Access Compliance Report Public Rights-of-Way (Curb Ramps)

Main Street: O_NEILL_DR Cross Street: MAYBECK_LN Location: SE

ADA ID: RPRK211025122135 Ramp Type: Type 1 - Perpendicular Diagonal Initial Pass/Fail: Fail Overall Compliance: No Severity Score: 2

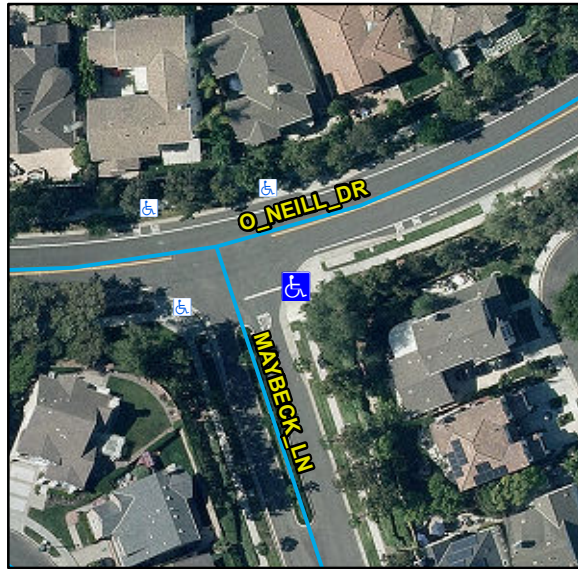
Compliance	Description	Data	Compliance	Description	Data
N/A	Ramp Length (in)	131	N/A	Flare Type LT	
Yes	Ramp Width (in)	48			N/A
Yes	Ramp Run Slope (%)	6.3	N/A	Flare Slope LT (%)	N/A
No	Ramp Cross Slope (%)	4.6	N/A	Flare Traversable LT	N/A
N/A	Landing Present	N/A	N/A	Flare Type RT	
N/A	Landing Length (in)	N/A			N/A
N/A	Landing Width (in)	N/A	N/A	Flare Slope RT (%)	N/A
N/A	Landing Run Slope (%)	N/A	N/A	Flare Traversable RT	N/A
N/A	Landing Cross Slope (%)	N/A	N/A	DWS Provided	N/A
N/A	Landing Movement Obstructed?	N/A	N/A	DWS Contrast	N/A
	Landing Movement Type	N/A	N/A	DWS Length (in)	N/A
N/A	Landing Shared	N/A	N/A	DWS Full Width	N/A
N/A	Clear Space	Yes	N/A	DWS Offset Left (in)	N/A
N/A	Clear Space To Crosswalk (in)	N/A	N/A	DWS Offset Right (in)	N/A
N/A	Marked Crosswalk 1	No	N/A	Marked Crosswalk 2	No
	Crossing 1 Direction	N		Crossing 2 Direction	W
	Marked Crosswalk 1 Width (in)	N/A		Marked Crosswalk 2 Width (in)	N/A

N/A	Ramp Inside Crosswalk 1	N/A	Yes	Ramp Inside Crosswalk 2	N/A
	Crossing 1 Slope (%)	6.4		Crossing 2 Slope (%)	3.1
	Crossing 1 Cross Slope (%)	0.3		Crossing 2 Cross Slope (%)	1.5
N/A	Gutter Ponding	N/A	No	Curb Slope	10.7
Yes	Gutter Lip Height (in)	0		Road Run Slope (%)	3.4
N/A	Gutter Run Slope (%)	N/A		Road Cross Slope (%)	3.2
N/A	Gutter Cross Slope (%)	N/A			
Yes	Overall Surface Condition: Acceptable		No	Perp Joint Present	No
	Cross Gutter Present?	No		Spandrel Present?	No
	Replace Cross Gutter?	N/A		Replace Spandrel?	N/A

Remove & Replace Curb Ramp With Two New Directional Ramps or Equivalent.

R304.2.2, R204.3, R304.5.3, STD 1115
